**DRIVER AND/OR PASSENGER SEAT WARMER(S) ARE
INOPERATIVE OR CANNOT BE TURNED OFF AND DTC B1520:49
MAY BE STORED**

Bulletin No.: 09-002/23

2023 CX-50 (with front seat warmer and without driver-side memory power seat) and (produced before December 2022)

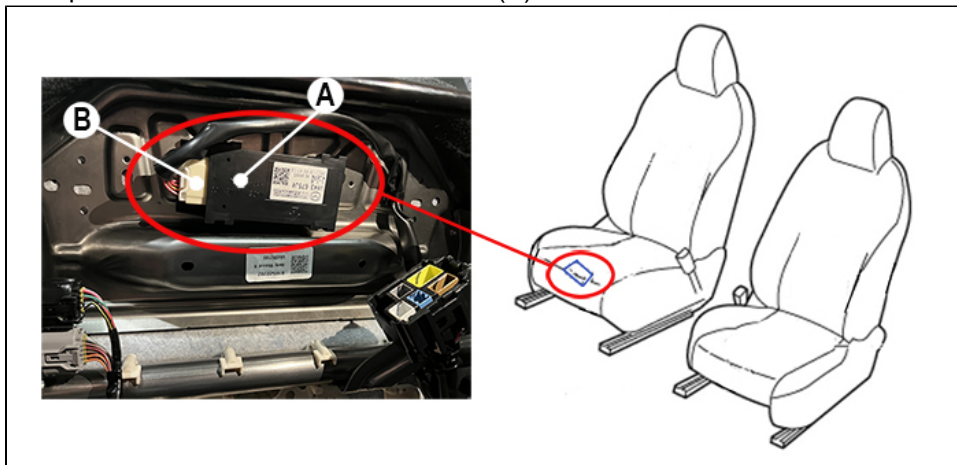
1. Verify the customer concern.
2. Replace the seat warmer control unit located on the front passenger seat according to the instructions in MGSS ([FRONT SEAT REMOVAL/INSTALLATION](#)).
3. Disconnect the Seat Warmer Control Unit connector [0913-101 \(B\)](#).
4. Replace the Seat Warmer Control Unit (A).

5. Install in the reverse order of removal. See MGSS ([FRONT SEAT REMOVAL/INSTALLATION](#)).
6. Verify the repair.
